NATIONAL TRANSPORTATION SAFETY BOARD

B737 Flight Control System
Critical Design Review Report
May 3, 1995

**B737 FLIGHT CONTROL
SYSTEM
CRITICAL DESIGN REVIEW
-REPORT-**

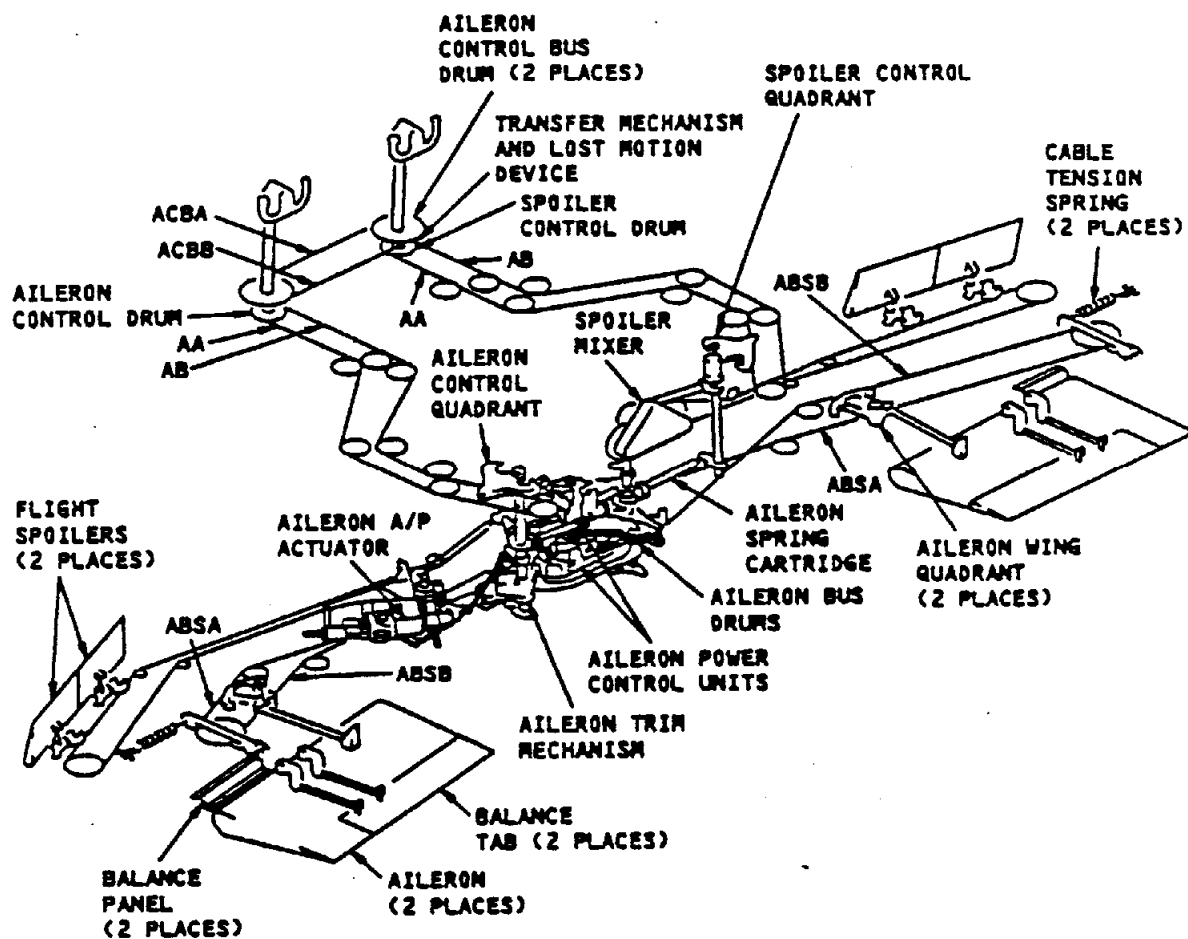
a. Single Failures, Aileron - The failure mechanisms identified in Table 1 suggest there are a number of ways for a failure to result in a sustained aileron hardover. The significance of the aileron failure conditions resulting in a jam of the aileron is the importance of the alternate means for controlling the airplane. The designed alternative means is the aileron transfer mechanism.

As was experienced in the "M" Cab exercise, flight path control through the aileron transfer mechanism may be very difficult due to the high wheel forces. It is believed that if a full aileron hardover was to be countered for any reasonable length of time, continued safe flight and landing in a B737 would be very difficult. (See "Recommendations For FAA Action," Section 15. Recommendation -8).

Failure conditions associated with the flight spoilers are also identified in Table 1. One or two panel failures (up) in the flight spoiler system did not produce a significant roll control problem as long as the rest of the lateral control system was operative. The significance of this failure is

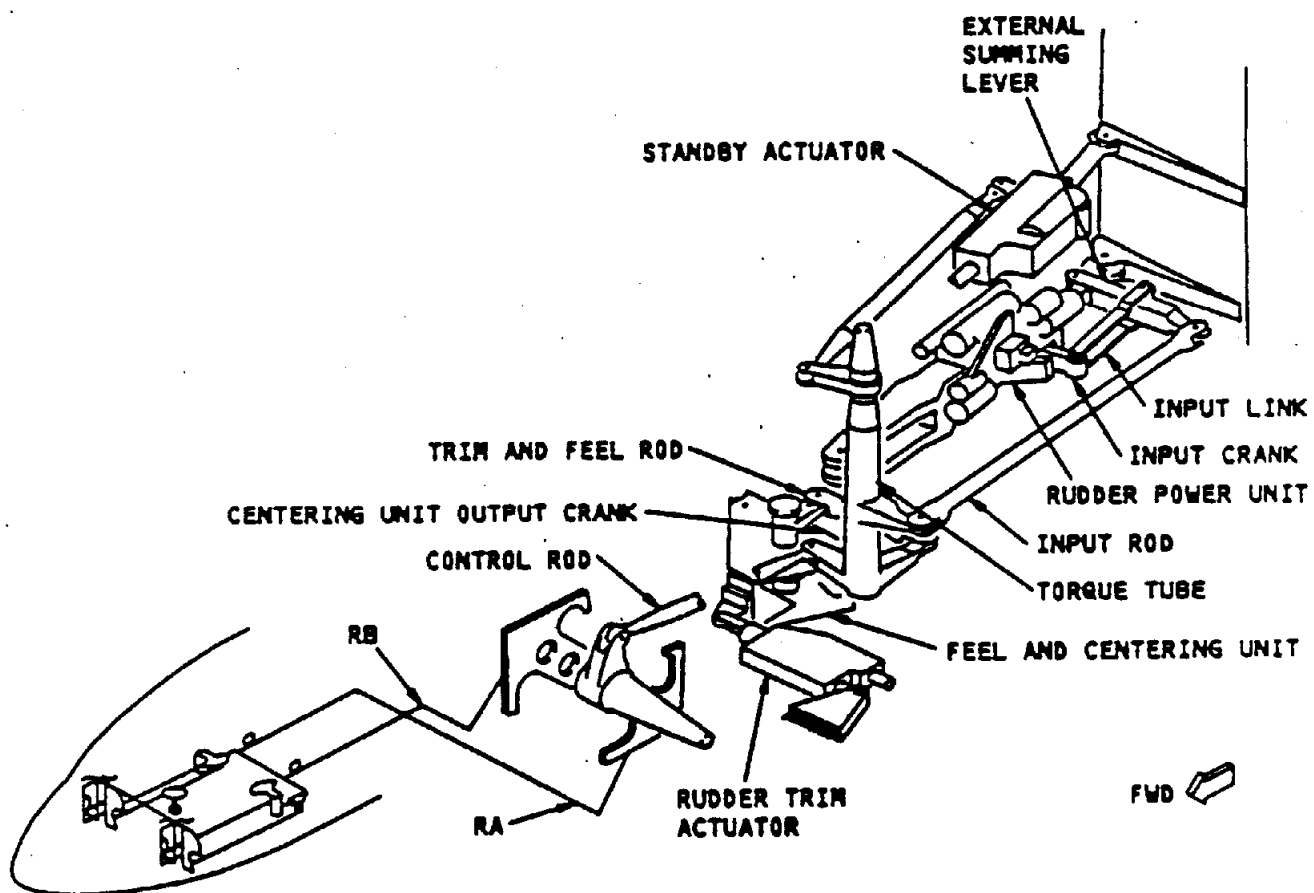
Failures identified in Items 7A and 7B of Table 2 are not of themselves "hazardous." However:

(1) They may initiate a more hazardous event, either flight controls or flightcrew related.

(2) They tend to mask and/or confuse other flight control anomalies that may be precursors or provide evidence of more hazardous failures.

Failures identified in Items 8 and 9 of Table 2 can be confusing to the flightcrew and could result in inappropriate flightcrew response. This is because the crew's primary indicator of rudder position is rudder pedal position, and these two failures cause displaced pedals and inoperative pedals. Flightcrew training in the recognition and proper response to these failures is recommended to assure continued safe flight and landing. (See "Recommendations For FAA Action," Section 15. Recommendation -19).
